Q&A #2

Date: June 25, 2014

Project: 01B46-14-0040- Fire Stopping Materials and Fire Damper installation in fire Rated Separations

SKA.01

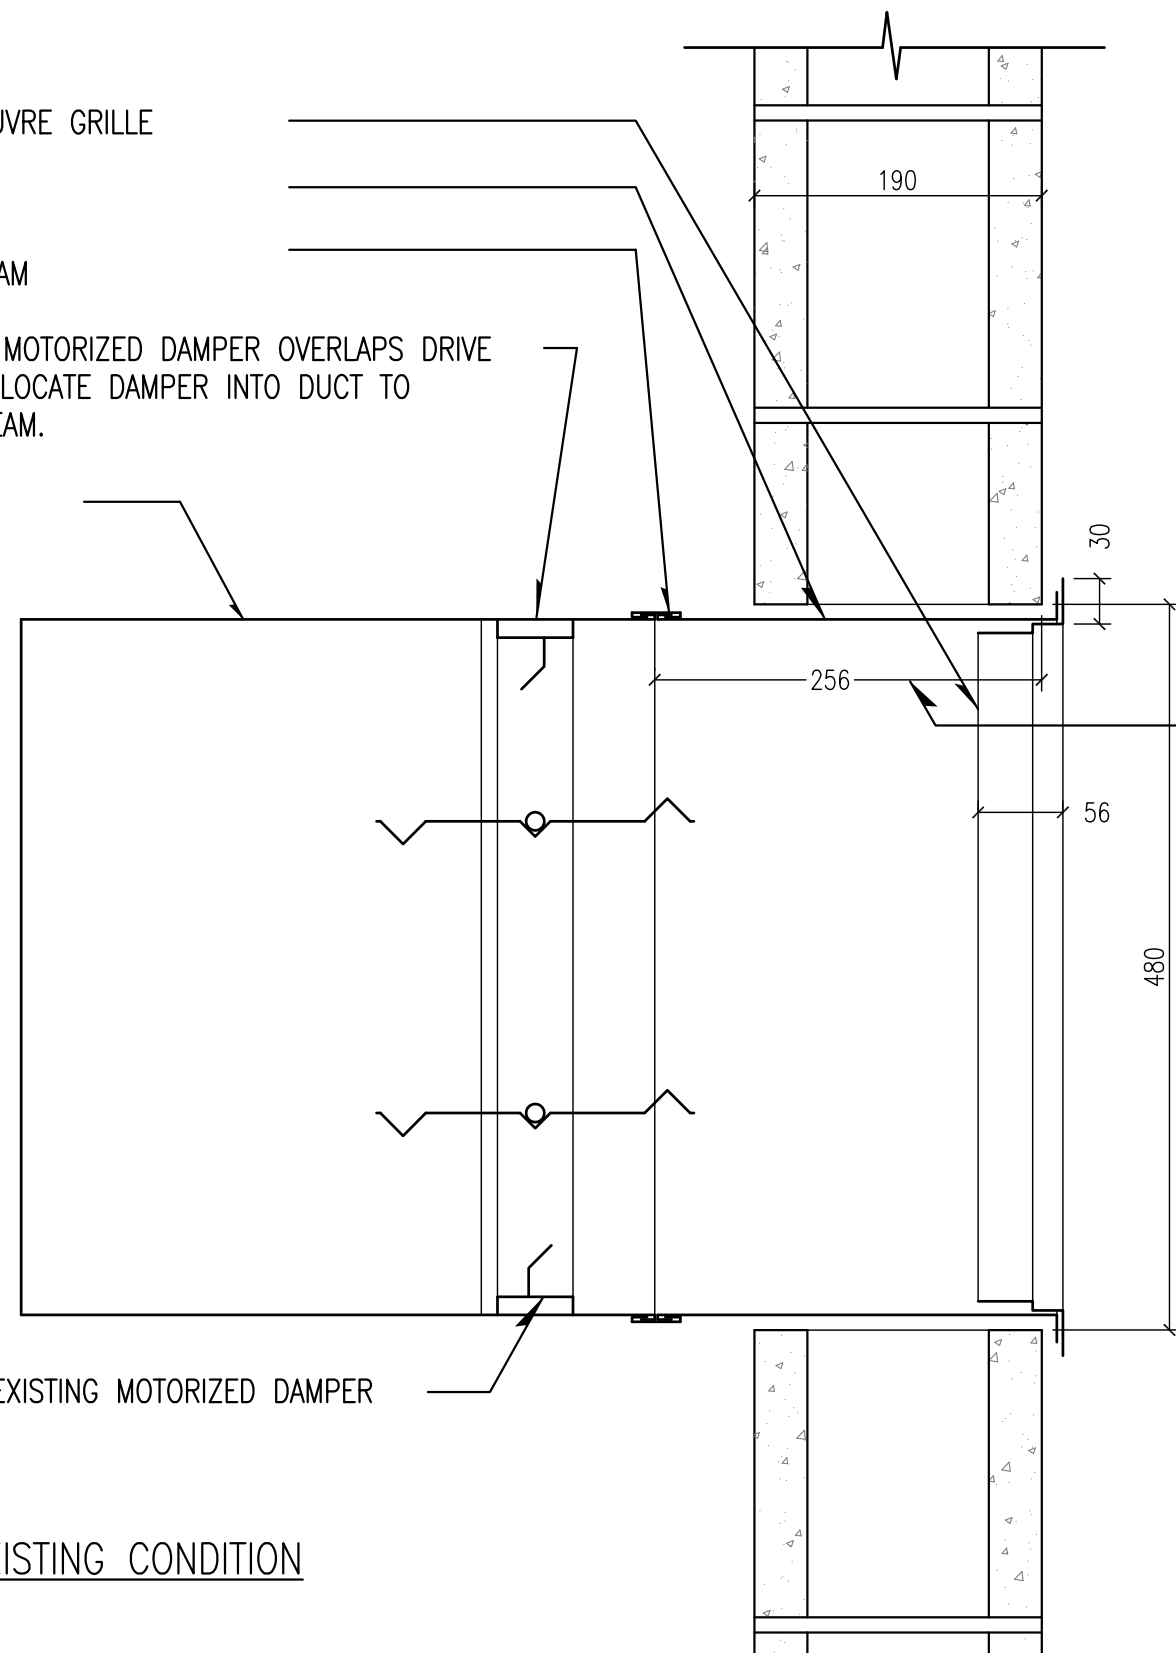
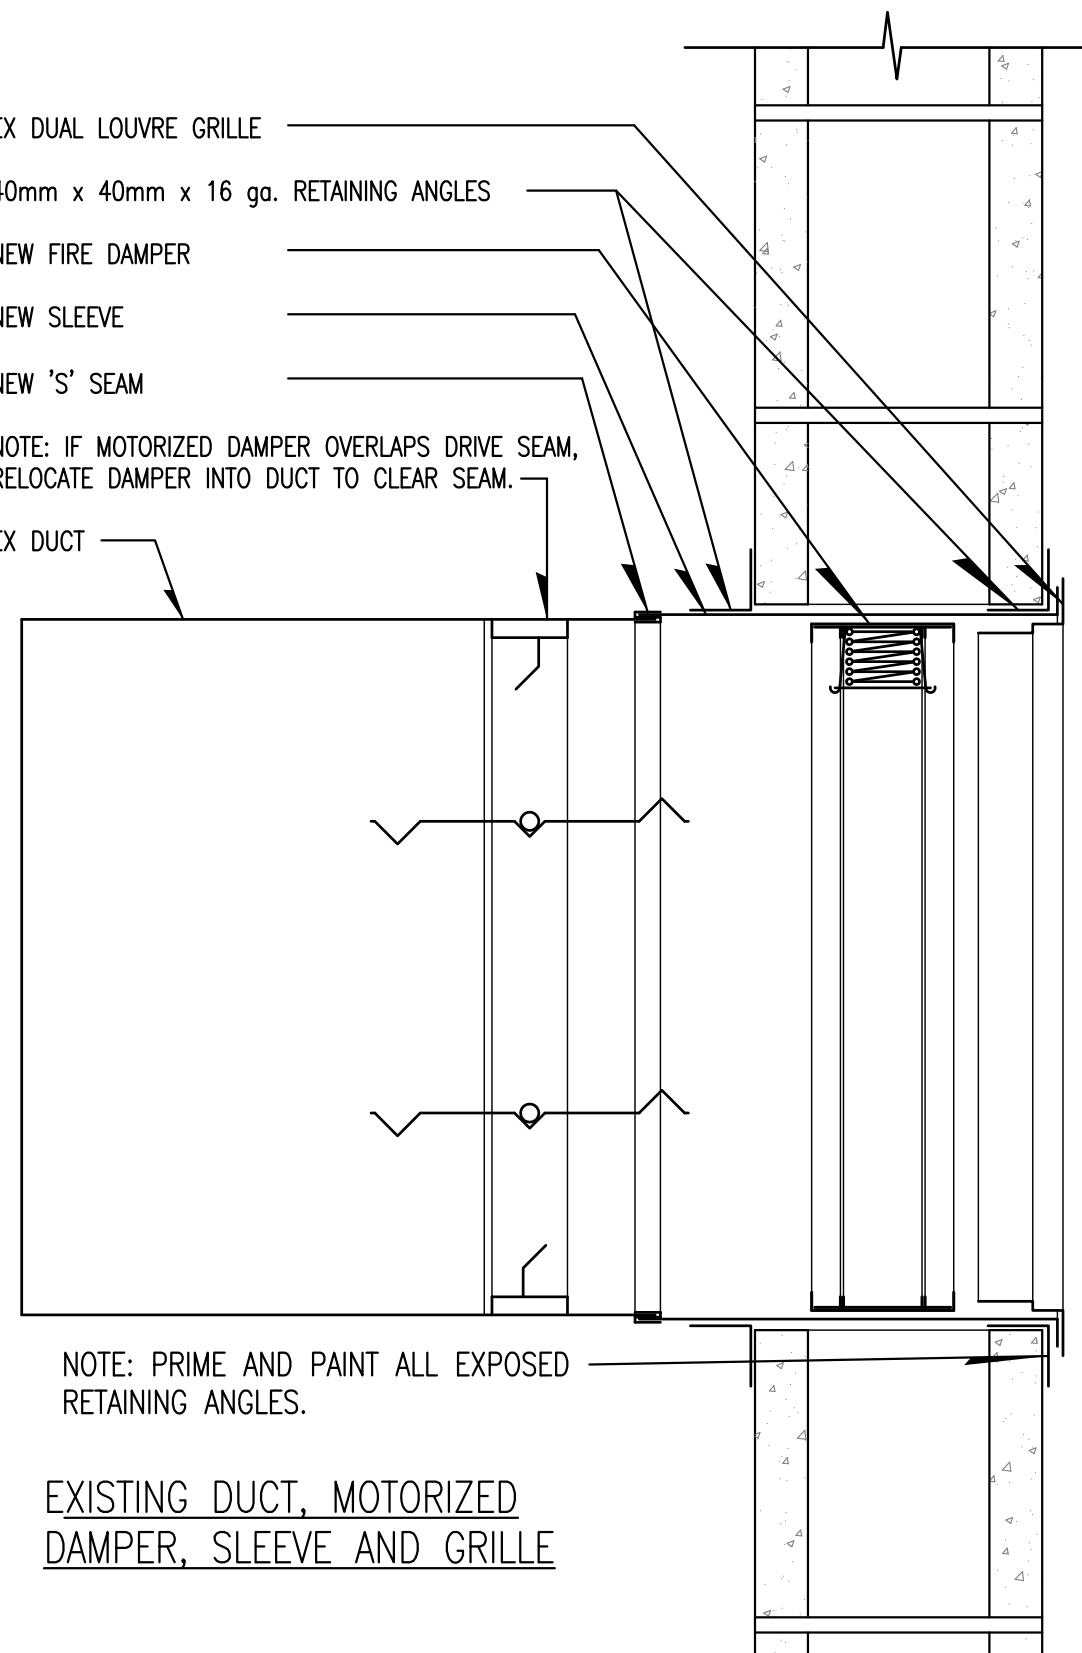
Q2. During the site visit on June 16, it was discussed and noted that there are existing actuated dampers in the return air ductwork (right at lab walls where the new fire dampers have to be installed). These existing dampers are not addressed anywhere in the tender documents. This concern was to be answered along with the other questions on Q&A #1 document. Saying that, are we going to receive any further direction/specs/etc on how these existing dampers relate to this tender as they can't remain in their present location?

If they need to be relocated, we need to know where they can be relocated to, the type/make of existing damper as the existing damper configurations may not fit in another location as the duct size changes and access is limited, so new dampers may be required. Advise.

It is showing the installation of new fire damper, retaining angles and sleeve. Note that SKA.1 also refers to the relocation if existing motorized dampers to ensure no conflicts between the existing motorized damper and the sleeve/duct connection.

A2. Please refer to the additional information attached to my Q &A #2. You will find two additional documents to answer your questions.

NOTE: IF MOTORIZED DAMPER OVERLAPS DRIVE SEAM, RELOCATE DAMPER INTO DUCT TO CLEAR SEAM.

NOTE: IF MOTORIZED DAMPER OVERLAPS DRIVE SEAM, RELOCATE DAMPER INTO DUCT TO CLEAR SEAM.

NOTE: PRIME AND PAINT ALL EXPOSED RETAINING ANGLES.
